Serial No. **09/978,550**

Docket No. **HI-0046**

Reply to Office Action dated September 21, 2005

AMENDMENTS TO THE DRAWINGS

FIG. 1

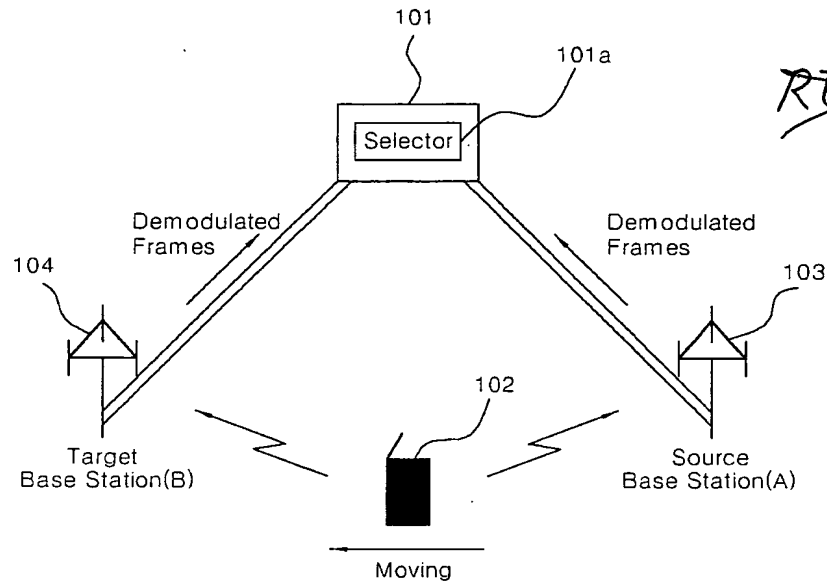
The Office Action states that FIGs. 1-5 should be labeled as "Prior Art." In order to further prosecution, each of FIGs. 1-5 has been labeled as "PRIOR ART." This is not an admission as to prior art.

*PRIOE
RELATED ART*

The attached drawings include changes to Fig. 1-5. These sheets, which include Figs. 1-5, replace the original sheets including Figs. 1-5. In the replacement sheets, "RELATED ART" has been replaced with "PRIOR ART."

FIG. 2

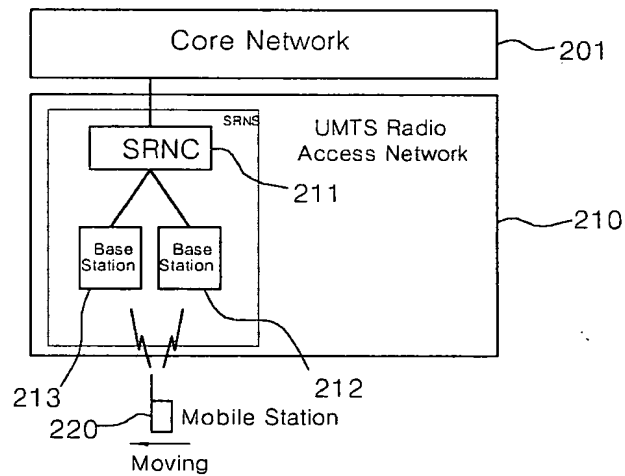
*RELATED ART
PRIOE*

FIG. 3

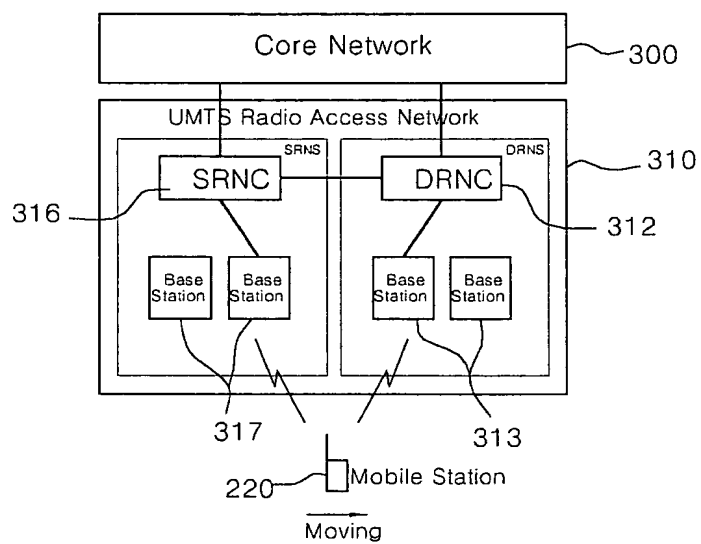
~~RELATED ART~~
Prior

FIG. 4

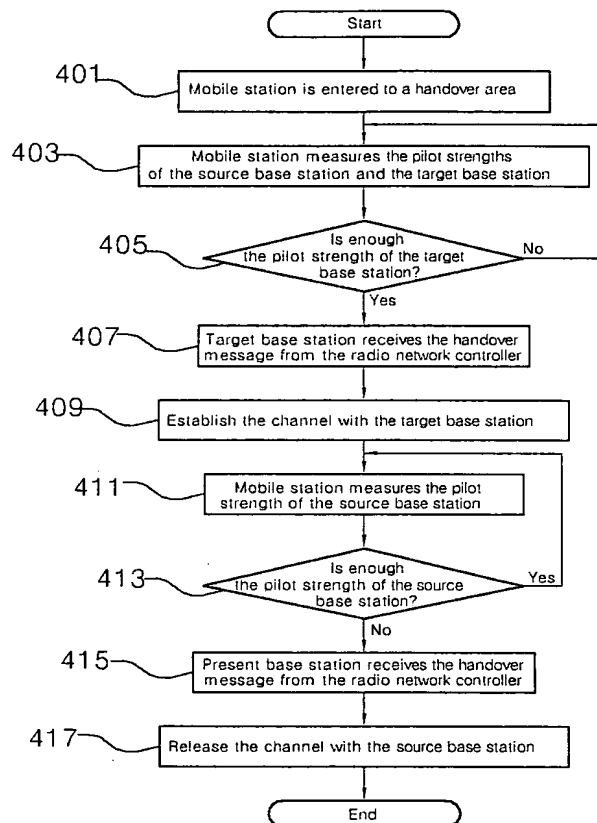
RELATED ART
PRIOR
